GEORGETOWN-SCOTT COUNTY PLANNING COMMISSION

**UK FEDERAL CREDIT UNION
PRELIMINARY DEVELOPMENT PLAN
Staff Report for the Georgetown-Scott County Planning Commission
April 9th, 2026**

Staff Report to the Georgetown-Scott County Planning Commission

FILE NUMBER: PDP-2026-15

L1
 LANDSCAPE PLAN

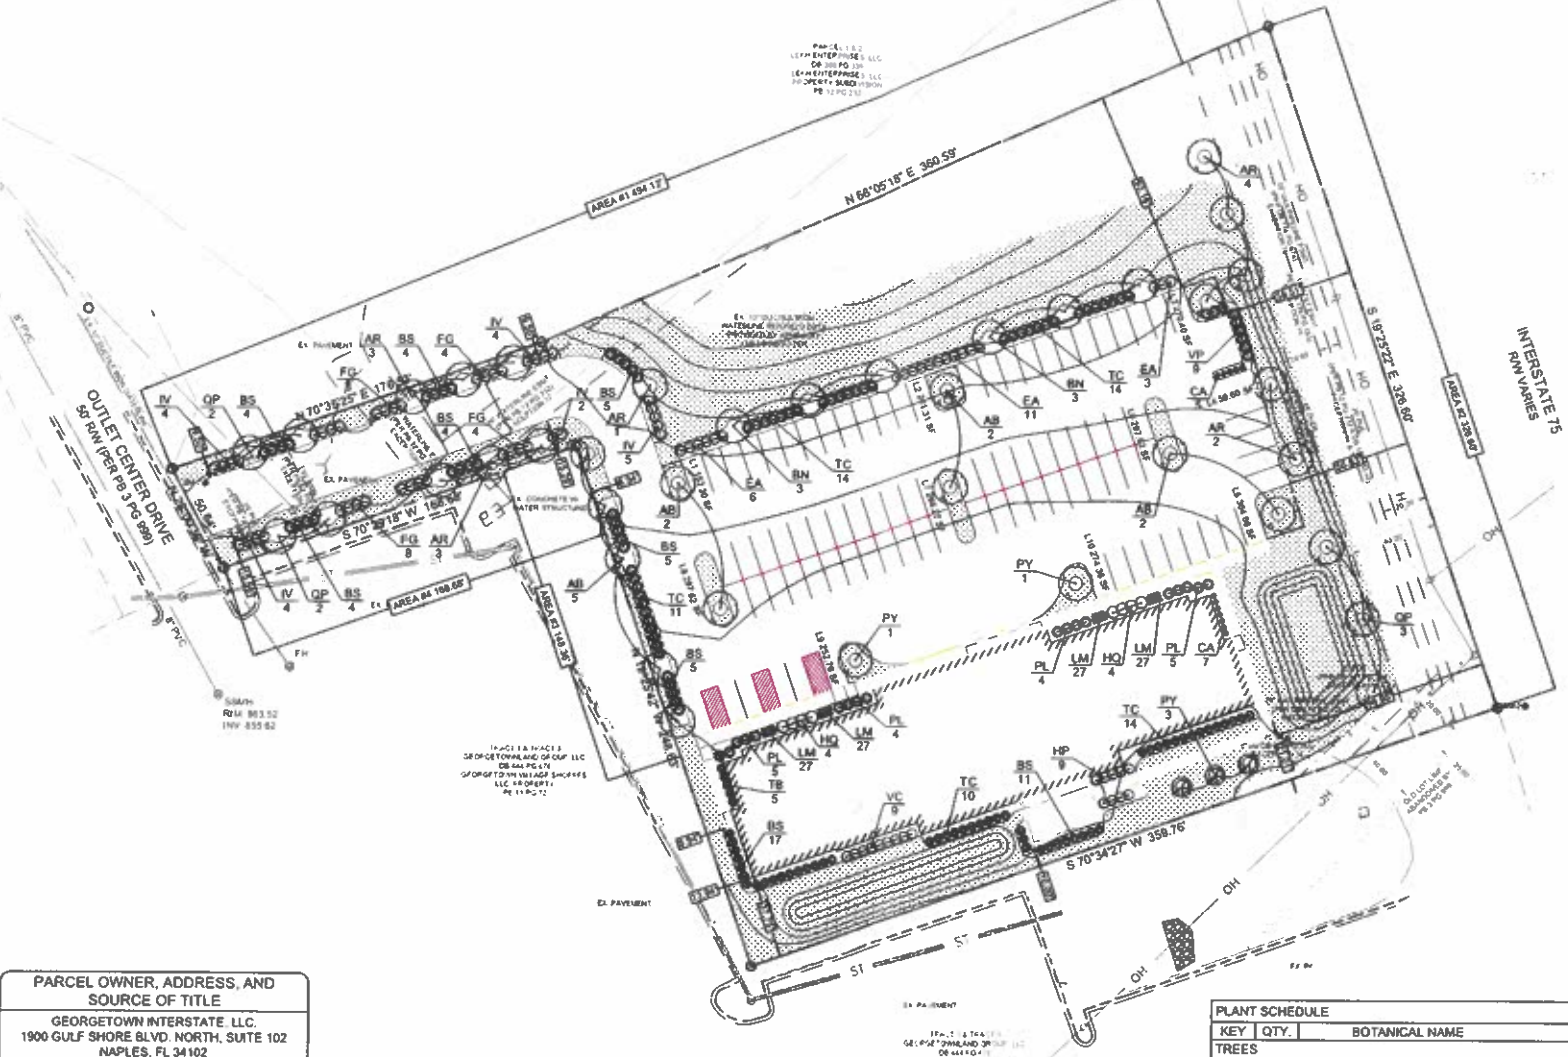
The Applicant is requesting a waiver to the requirement for the location of the 10-foot-buffer and the installation of the 6-foot-tall continuous buffer requirements. In a submitted letter, the Applicant states that the request for relocation of the 10-foot-buffer is due to numerous utility easements and lines being installed parallel to the interstate. They propose establishing a 40-foot-wide no impact area where the easements are located so as to not interfere with those utility easements and lines. The Applicant states that they would not remove the existing vegetation in the 40-foot-wide buffer area. The Applicant proposes the installation of the required trees outside of the utility easement in accordance with the regulation. Ultimately, Staff recommends in favor of this request given that the width of preserved planting area would greatly exceed the requirements and that the existing mature plantings meets the intent of the *Landscape and Land Use Buffers Ordinance*.

The Applicant proposes the preservation of an unspecified area of existing tree canopy, however the planting of 21,350 SF of new canopy as part of the required property perimeter, vehicular use area perimeter, and interior landscape areas, equivalent to 17.6% of the total site area. Without information on the retained tree canopy, it cannot be determined if the landscape plan satisfies the landscaping requirement. The Applicant is aware of the requirement. The final landscape plan shall need include the preserved tree canopy and satisfy the requirements of the *Ordinance*.

The applicant has proposed a planting plan on Sheet L1 to demonstrate how this site will have a Landscape Buffer along the I-75 frontage that complies with the intent of the Landscape Ordinance.

Existing vegetation in this 40' wide corridor will remain undisturbed and parking lot perimeter planting will in tandem satisfy the intent of the Landscape Ordinance.

7. The Applicant shall receive Georgetown Fire Department approval as part of the Final Development Plan.
8. The Final Development Plan shall satisfy the requirements for minimum site tree canopy and shall include a specie specific landscape plan.
